STAFF RECOMMENDATION
1719 5th Avenue North
August 19, 2015

Application: New construction—addition
District: Salemtown Neighborhood Conservation Zoning Overlay
Council District: 19
Map and Parcel Number: 08108046100
Applicant: Derek Hoevel, property owner
Project Lead: Paul Hoffman, paul.hoffman@nashville.gov

Description of Project: The application is for a rear addition that is wider and taller than the contributing building.

Figure 2. The front elevation historically, with noncontributing addition lower to the side.

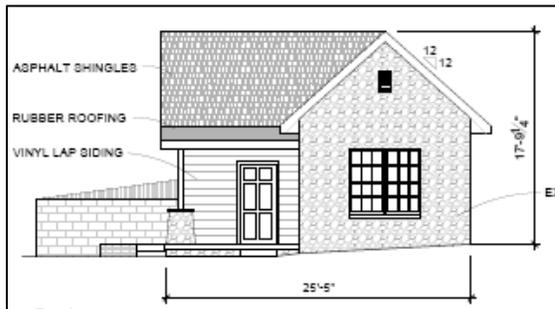
The proposed eave height matches the existing eave height of the house. The foundation height as drawn is approximately eight inches (8") taller than the existing foundation height; Staff recommends the foundation height be consistent with the existing foundation height. With this condition the project will meet section II.B.1.a. and b.

the front elevation shows the front door one foot (1') taller than the existing door opening (see Figures 2 and 3). In February 2014, Staff recommended disapproval of the alteration of the primary entrance. Staff recommends the same for this application. With this change, staff finds the project's proportion and rhythm of openings will meet Section II.B.1.g.

1719 5th Avenue North
South Elevations

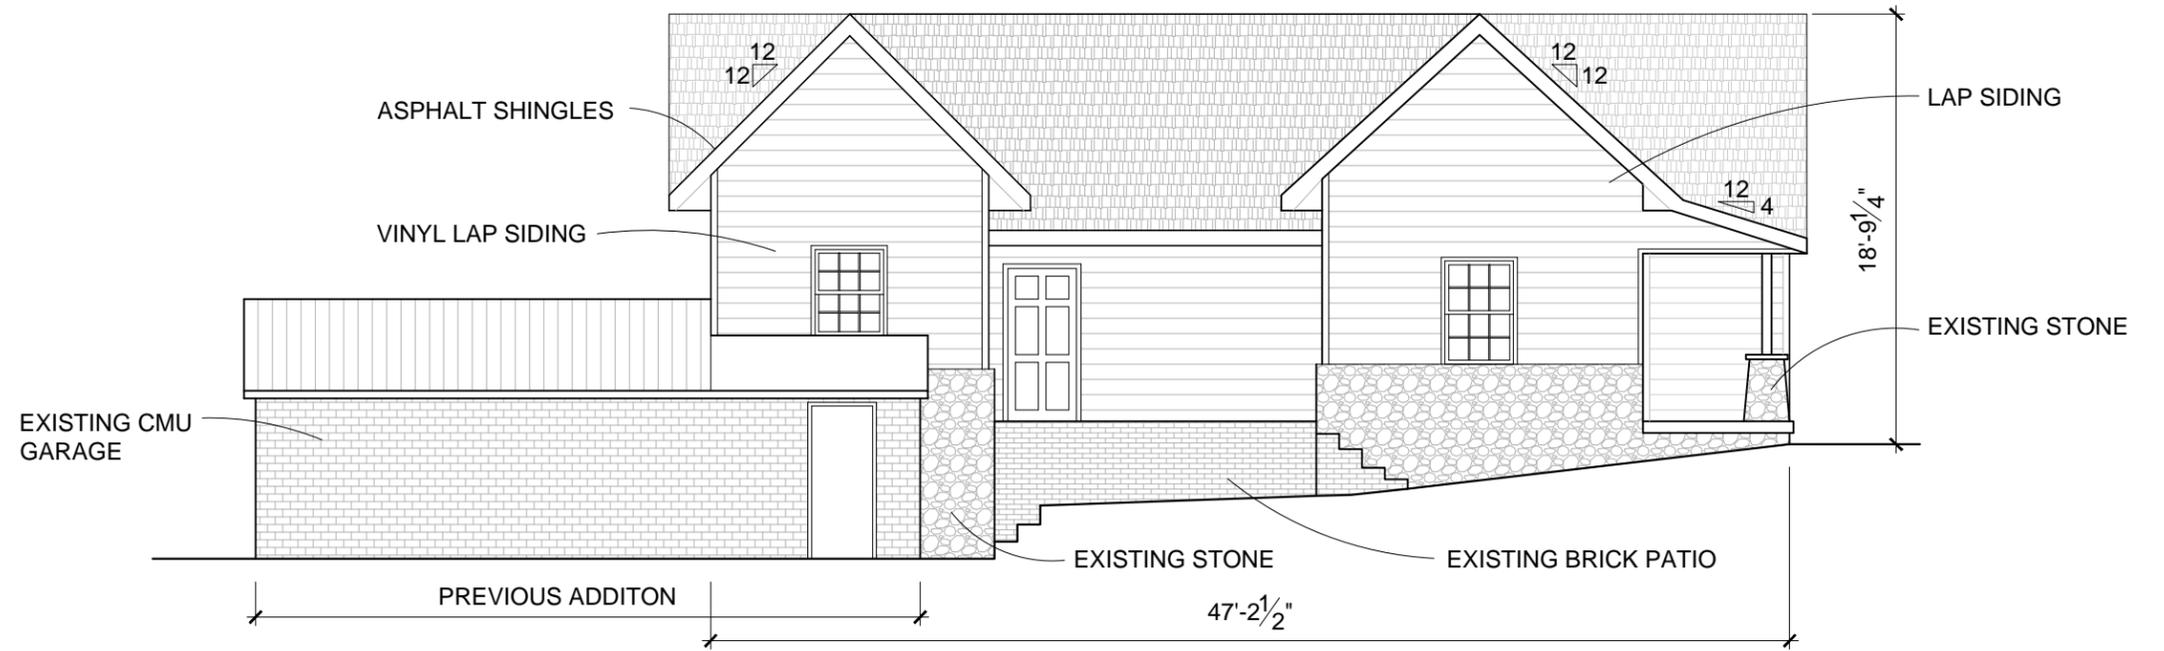
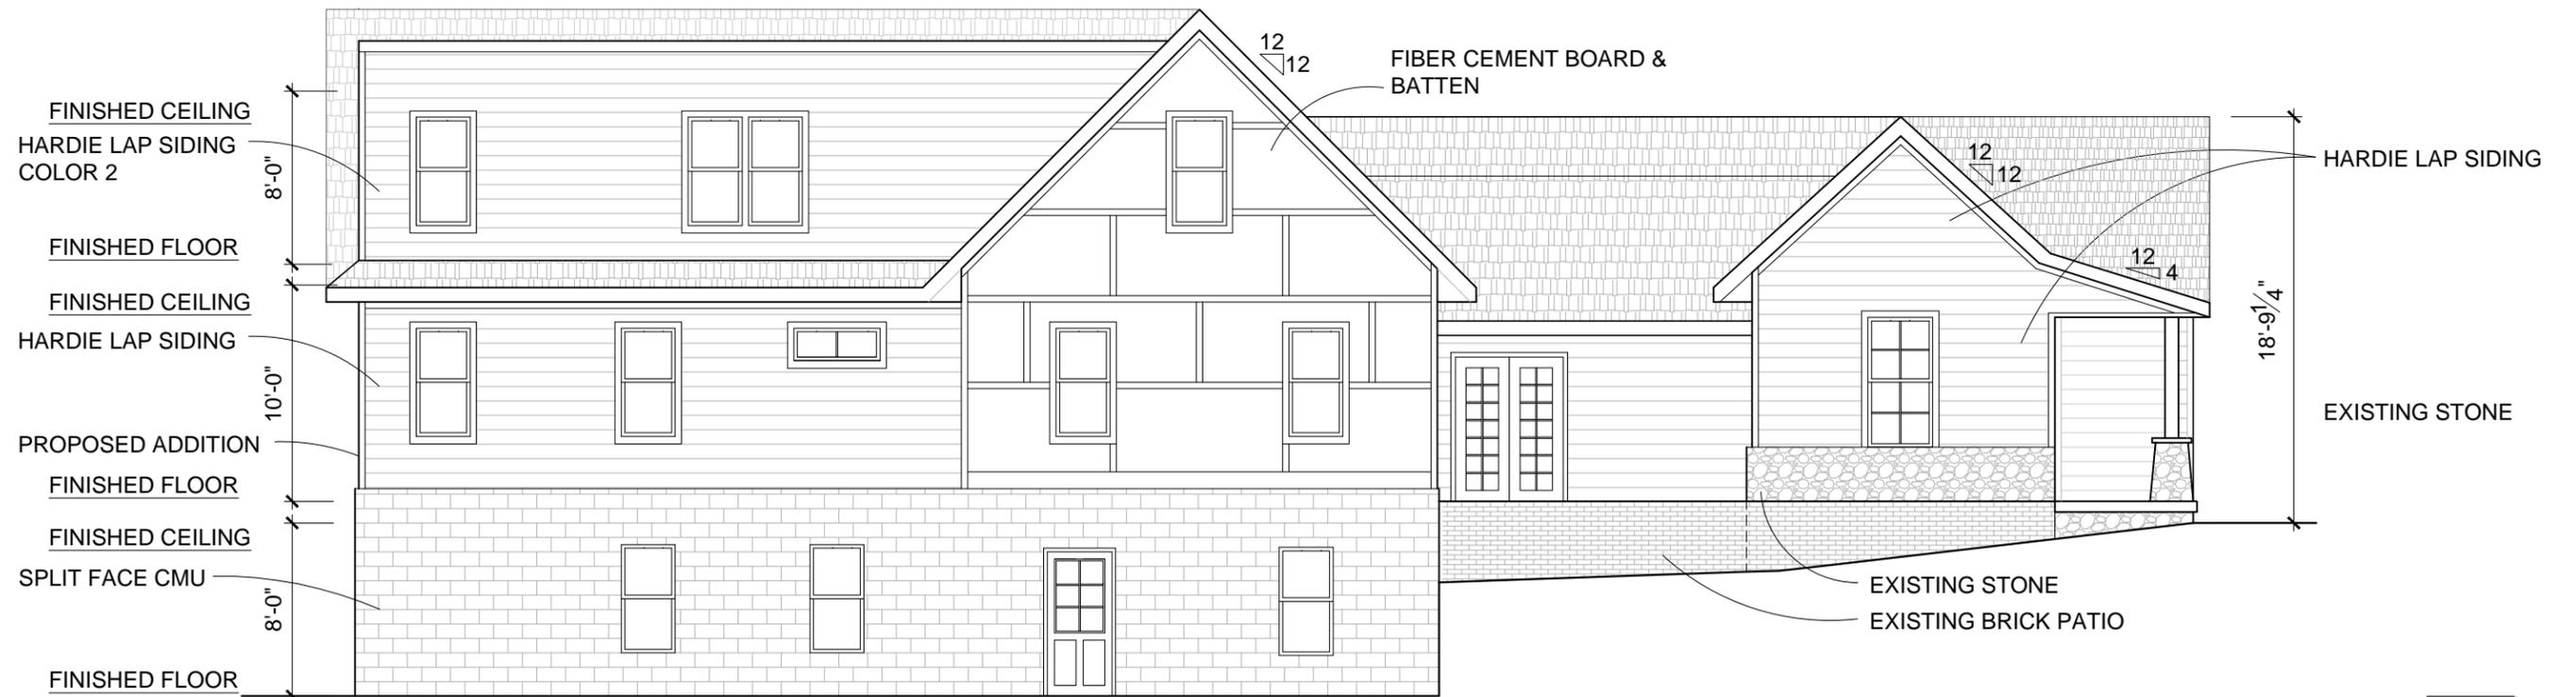
Roof form: The addition's roof form is complicated. The right side continues the existing gabled roof to the rear, with a long shed dormer along most of the addition. This dormer is set back one foot (1') from the wall beneath. On the left side, the existing side-facing gable will be enlarged, both upward and to the rear. To the rear of the new enlarged gable, the rest of this side has a flat roofed second-story. Section C of the design guidelines on additions specifies that the cheeks of a dormer should be at least two feet (2') from the wall below; this dormer stacks directly on the wall beneath on one side and against the gabled form on the other side, creating essentially a third story instead of a dormer. Staff recommends that each of the dormers be redesigned to set back two feet (2') from the wall beneath and two feet (2') from the gabled roof form. In addition, staff finds the flat roof of the left side dormer allows for an expanse of wall space that is out of scale, and recommends that its pitch be increased to help mitigate the wall area here.

1. The foundation height of the addition maintain the existing foundation height;
2. The side dormers be redesigned to set back at least two feet (2') from the wall beneath and two feet (2") from the gable;
3. The dormer on the south elevation have its roof pitch increased, to reduce the visible wall area;
4. The front door opening remain the same dimensions, unless evidence exists that it was a larger opening historically;
5. Lap siding will have a reveal no greater than five inches (5");
6. Staff provide final approval of all materials, including windows & doors.
